**ADDENDUM NO. 2**

**TO THE REQUEST FOR PROPOSALS FOR  
TUCSON AIRPORT AUTHORITY PROJECT**

**10122470 REPLACE PARKING AND REVENUE CONTROL SYSTEM (PARCS)**

**January 25, 2023**

# MAIN LOT (HOURLY & DAILY)

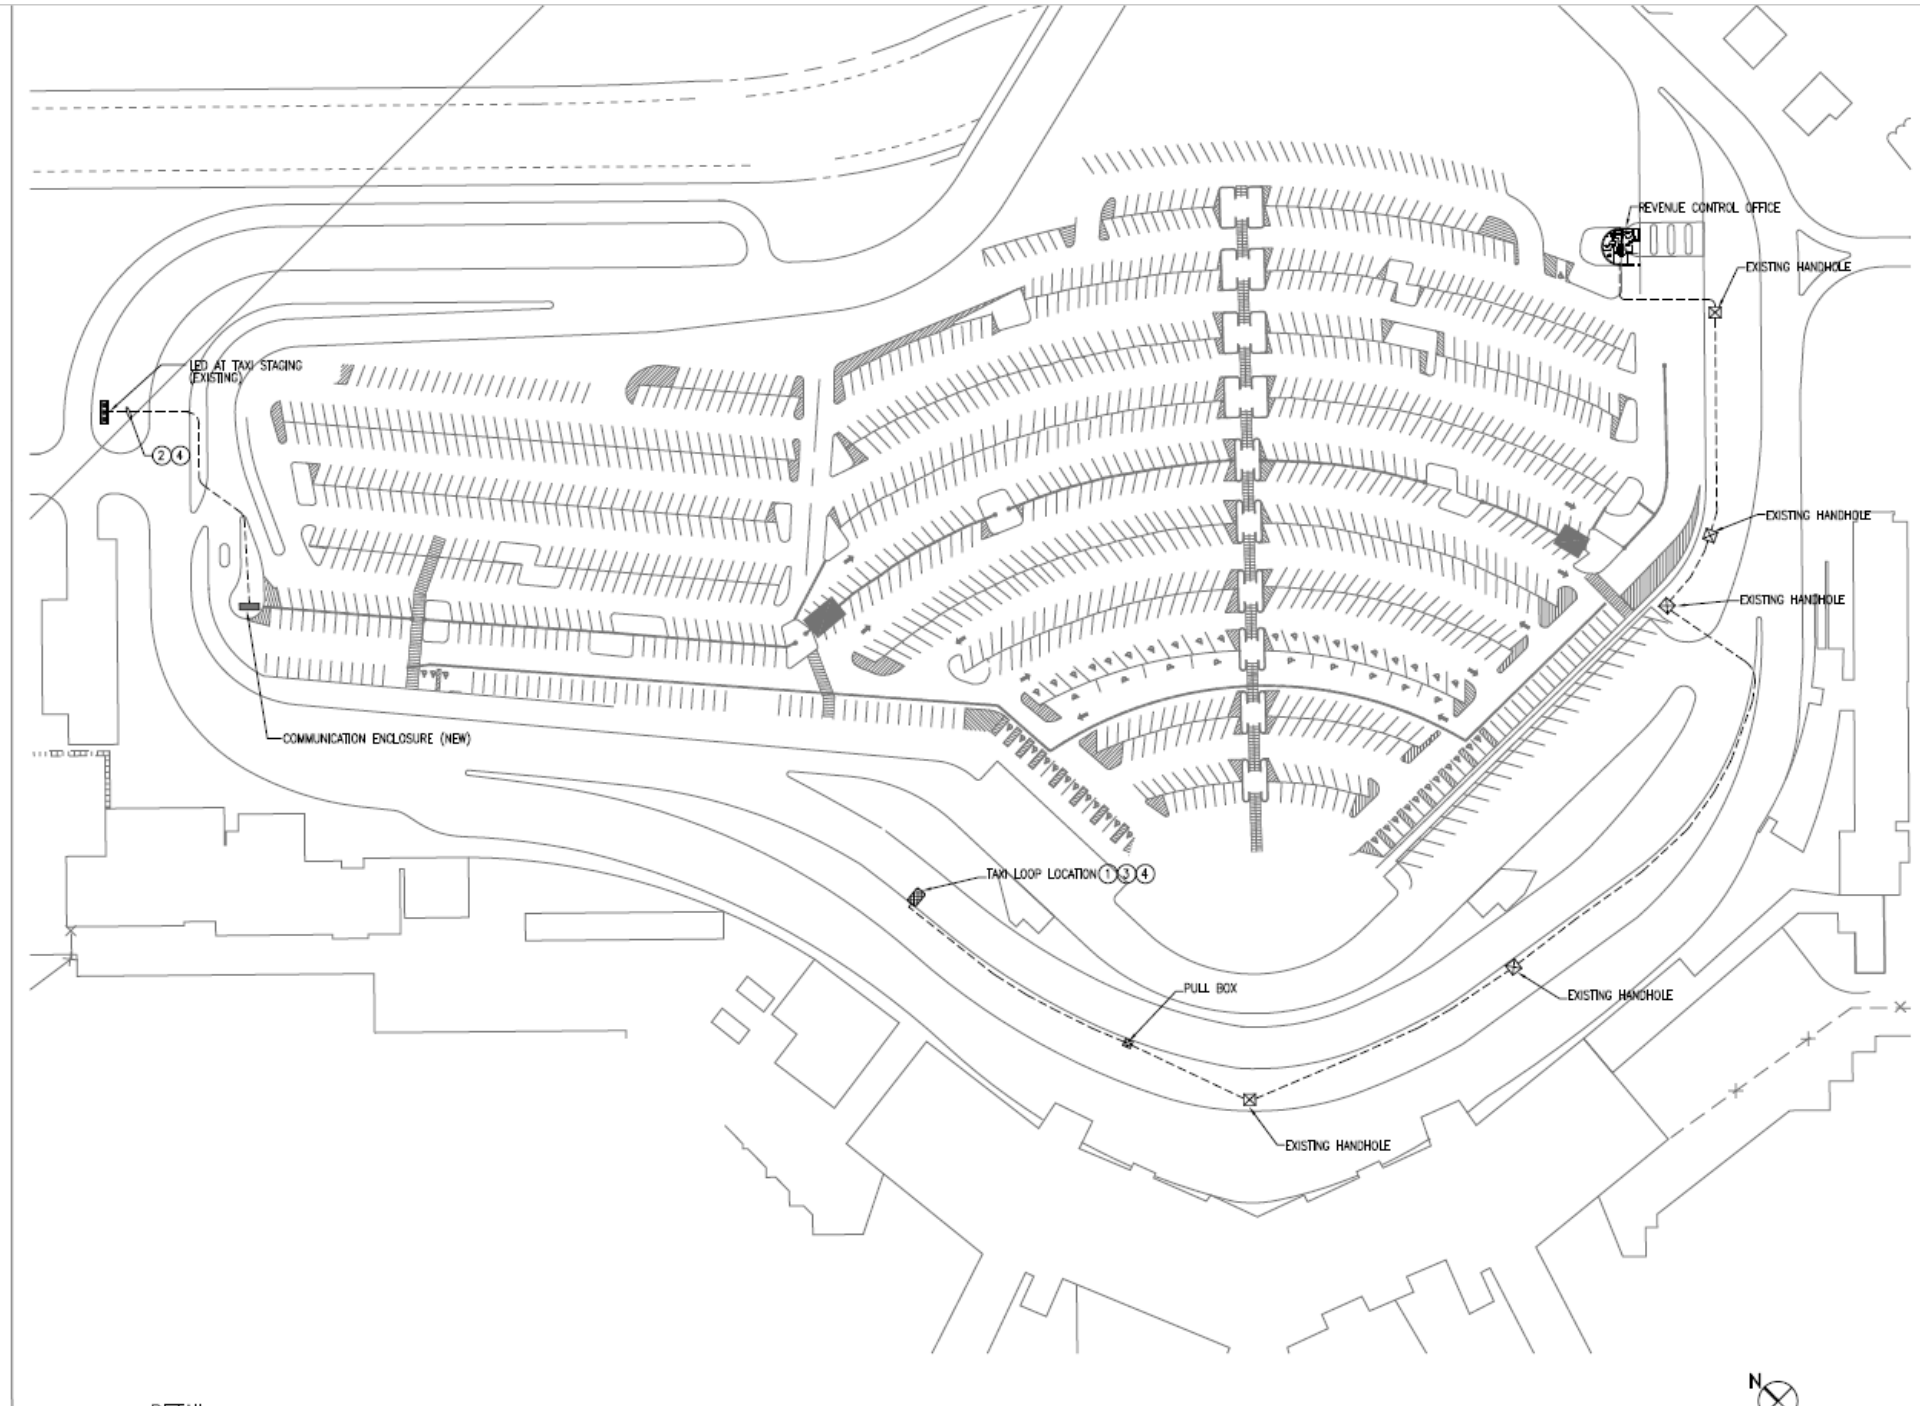
3. Section 5.4 of the RFP stated that the Airport is wanting the PGS installed to the solar panels on the surface lot. Addendum 1 is stated only PGS is required on Level 2 of the garage. Can you verify of the Airport will require a cost proposal for PGS on the surface lot mounted to the solar panels?

4. The maps are helpful they unfortunately do not provide the information needed in order to properly spec out the parking guidance system. If TAA does not provide as-built drawings it will be difficult for vendors to provide an exact cost. With that said, is TAA willing to evaluate proposals that include estimated pricing for the parking guidance system?

Answer: The Parking Guidance System is needed for both the Main Lot (Daily/Hourly) and the 2<sup>nd</sup> level of the Parking Garage.

Answer: Drawings of the Hourly/Daily, Economy, and Garage parking spaces are attached. Estimated pricing for the parking guidance system is acceptable.
